FOONLY INC.		PANOFSKY BOX INTERFACE ADDRESS LATCH AND PARITY		22-JAN-80 17:11	
DRAWN BY: PHIL GOSSETT		PAGE OF		NUMBER	
APPROVED BY:		PROJECT:		REV.	
				PAN2.DRW [4,71]

FOONLY, INC		PANOFSKY BOX INTERFACE CONTROL		22-JAN-80 19:33	
DRAWN BY: PHIL COSSETT		PAGE 1 OF 1		NUMBER	
APPROVED BY:		PROJECT:		REV.	
				PAN3.DRW [4,71]

FOONLY INC.		PANOFSKY BOX INTERFACE CONTROL		22-JAN-80 20:06	
DRAWN BY: PHIL GOSSETT		PAGE OF		NUMBER	
APPROVED BY:		PROJECT:		PAN4.DRW [4,71]	
				REV.

FOONLY INC.		PANOFSKY BOX INTERFACE		22-JAN-80 20:02	
		CONNECTORS		PAN5.DRW [4, 71]	
DRAWN BY:	PHIL GOSSETT	PAGE	OF	NUMBER	REV.
APPROVED BY:		PROJECT:

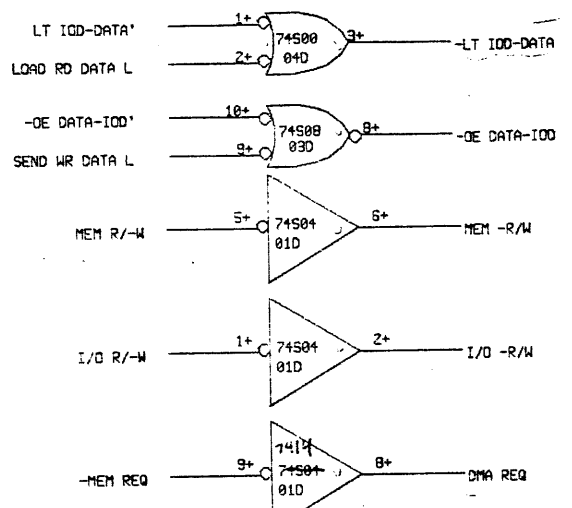
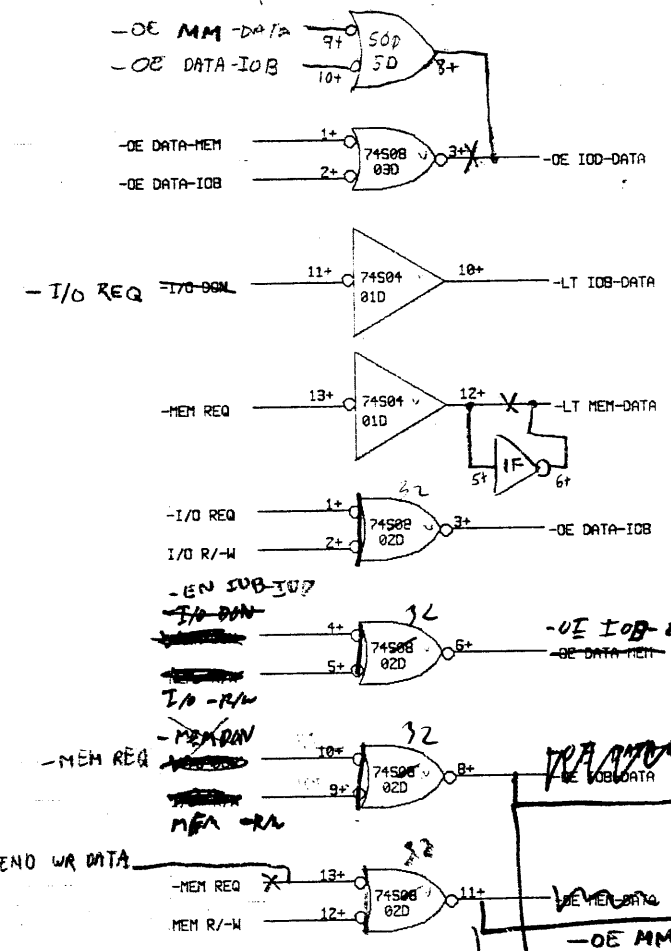
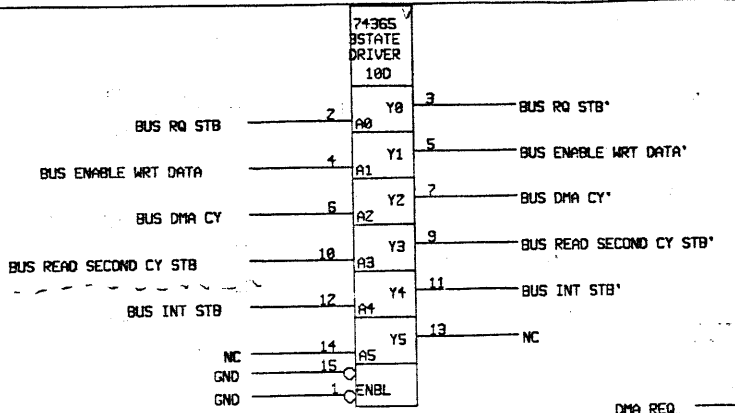
*This must really be
-OE IOB-DATA
744500*

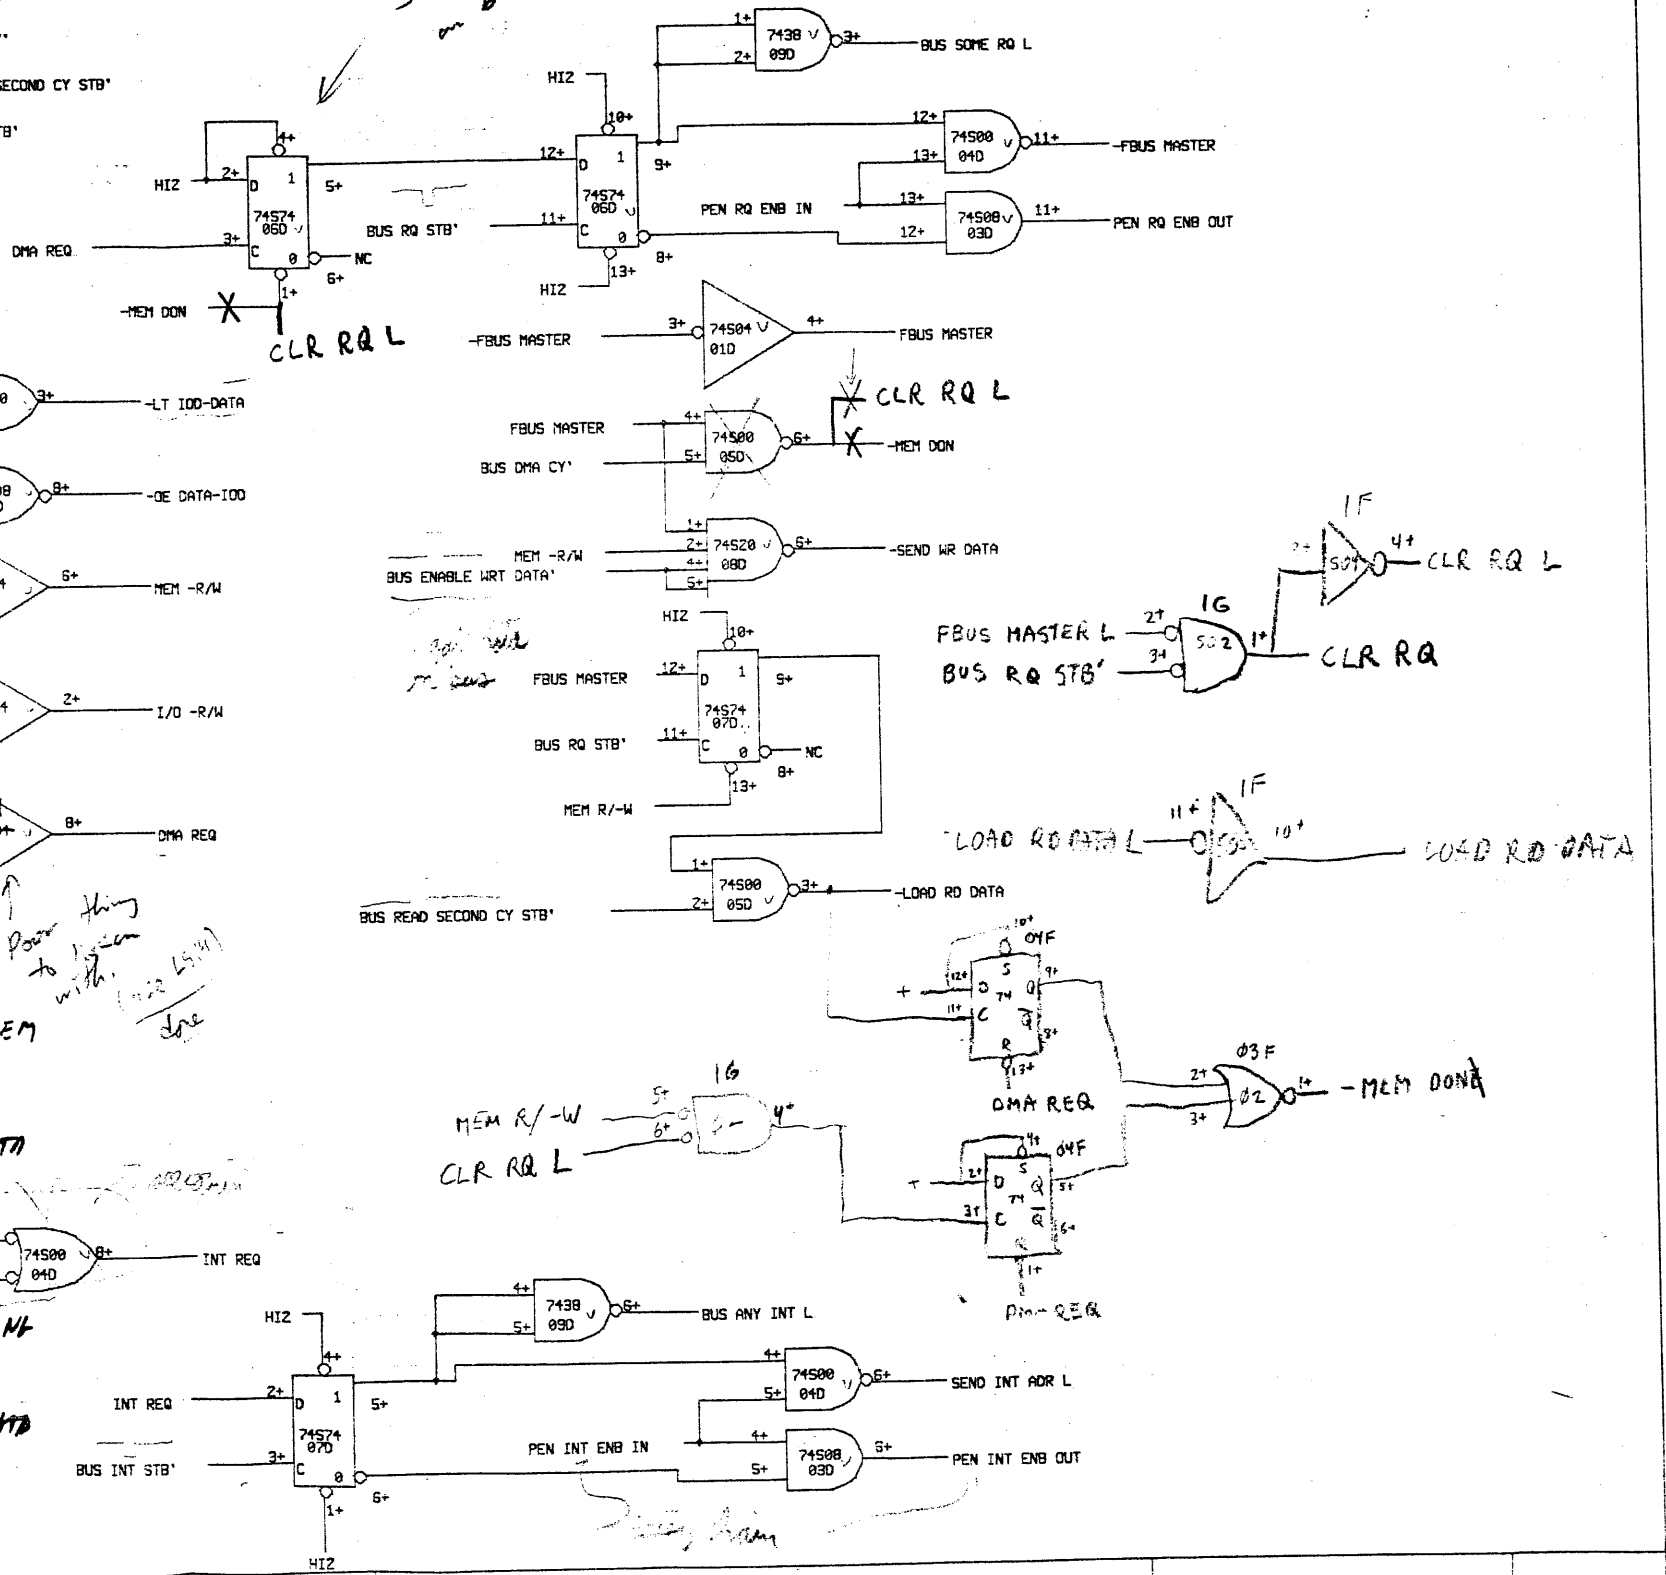
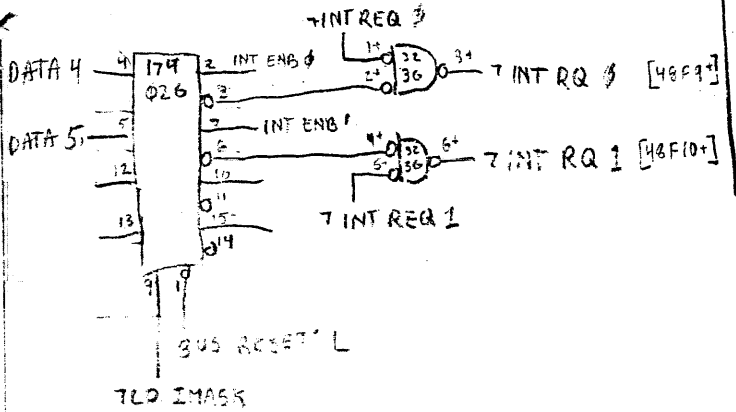
*is not allowed
on BUS RESET!*

*Power thing
to be done
with
(see LHM)
Joe*

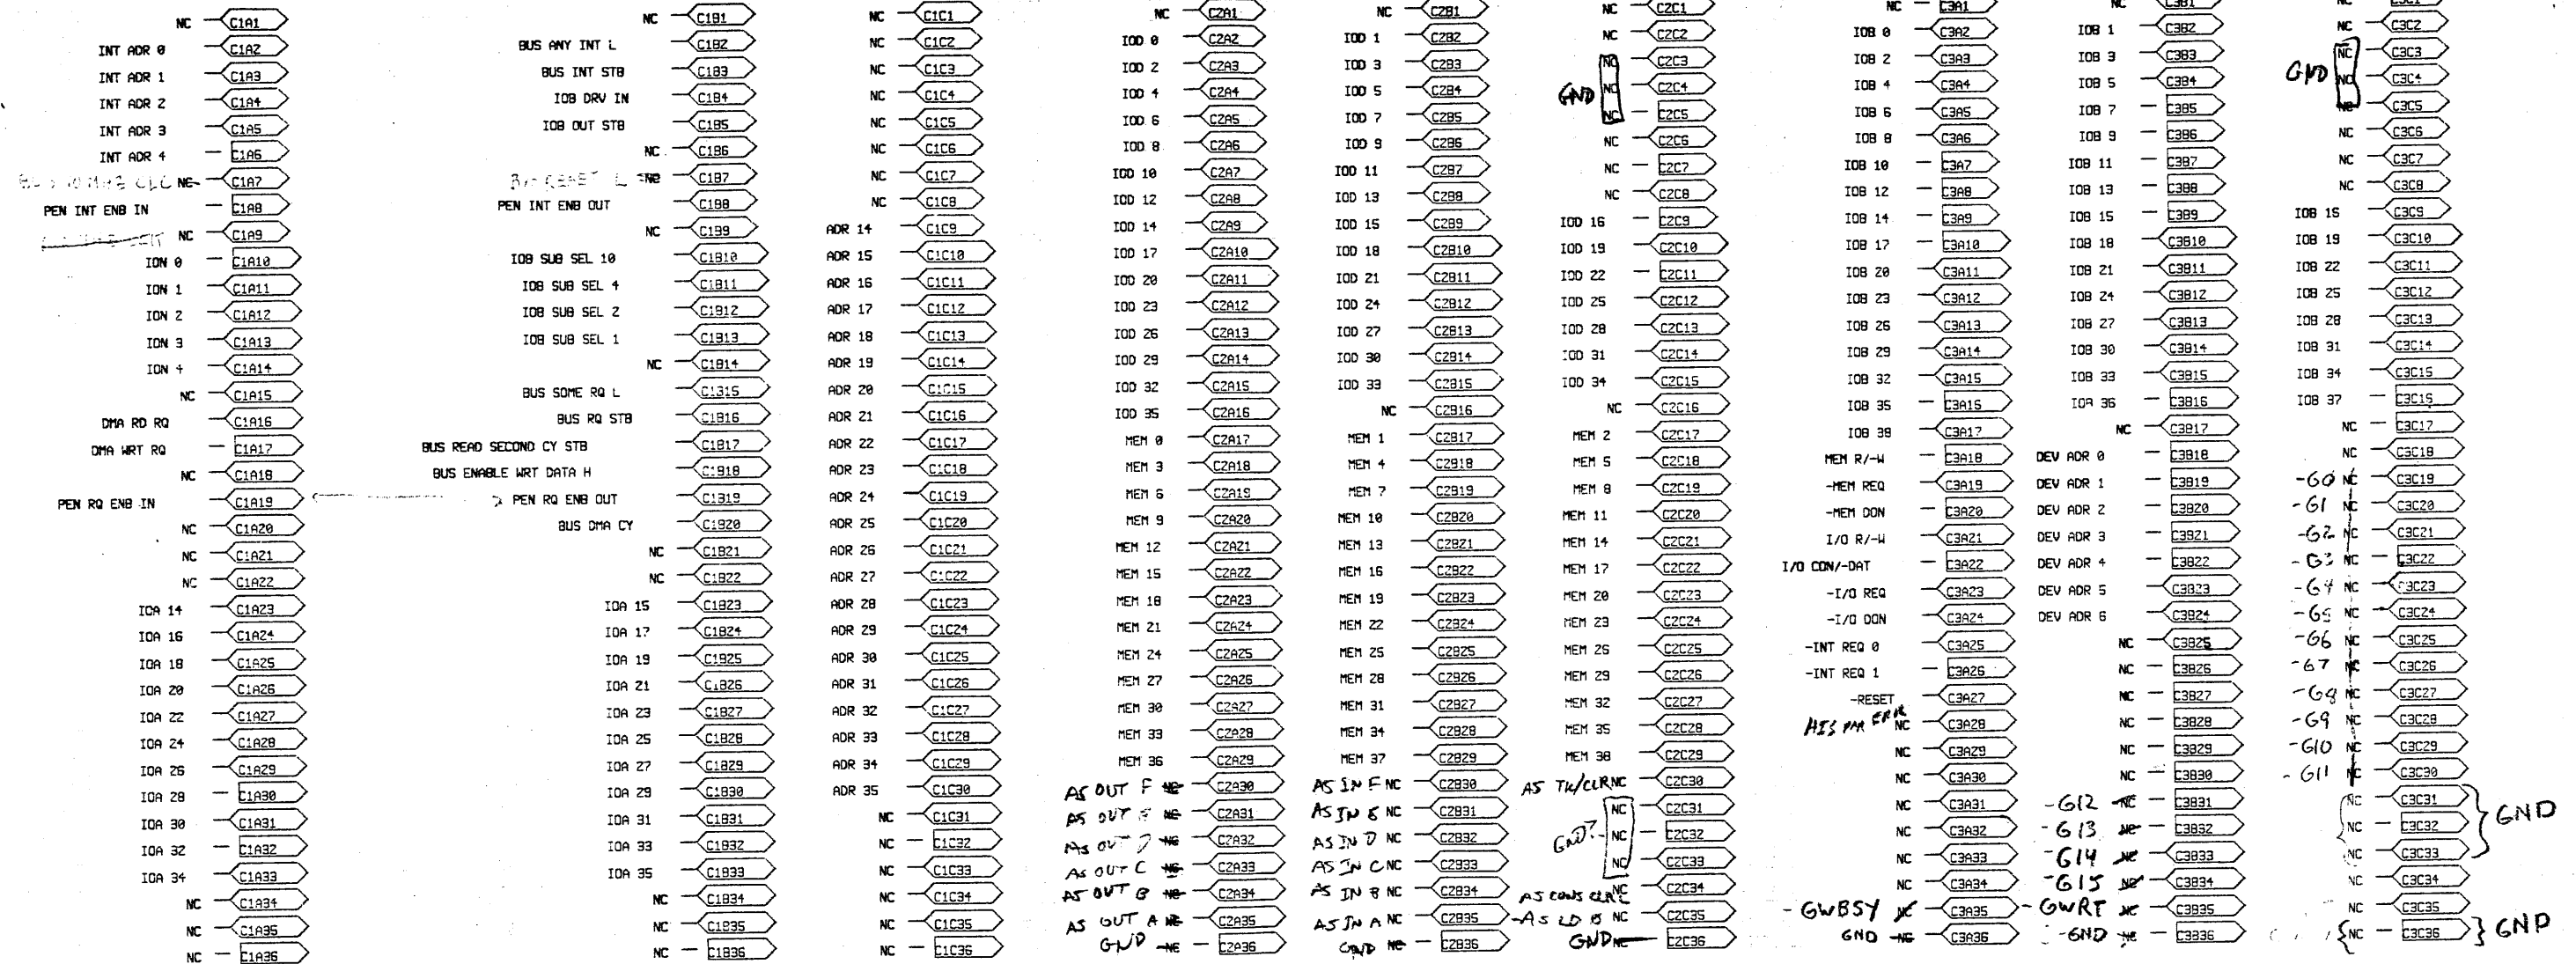
10 Mhz clock on upper 9C3A29 (CON1) BUS 10 MHZ CLC
